Technical Service Bulletin

97AT UPDATE – Fuse (NVLW)

September 18, 2014

Model(s)	Year	VIN Range	Vehicle-Specific Equipment
RS7	2014	See Campaign/Action screen in Elsa	None

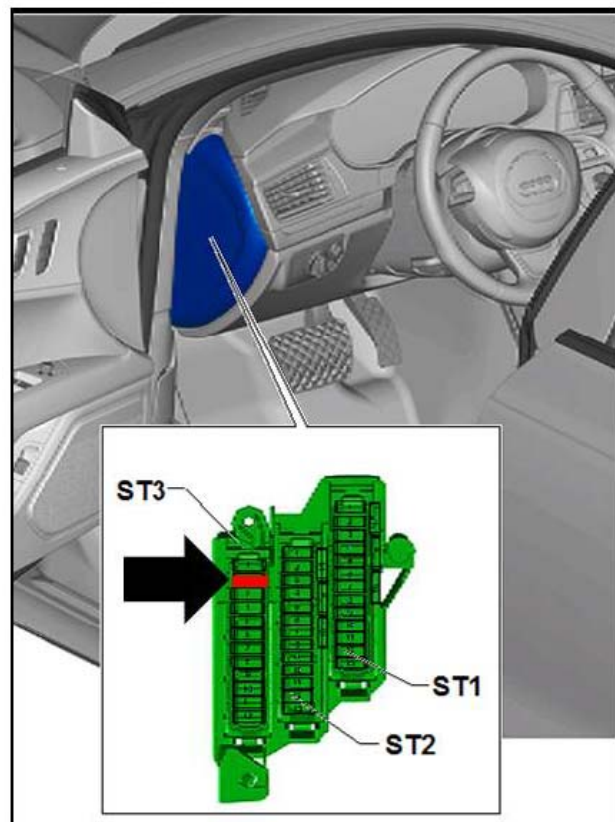
1. Using trim stick remove cover <1> on driver side of the dash panel.

2. On Fuse holder B, fuse carrier ST3 (red) replace fuse 2 with new fuse N 017 131 16 or equivalent.
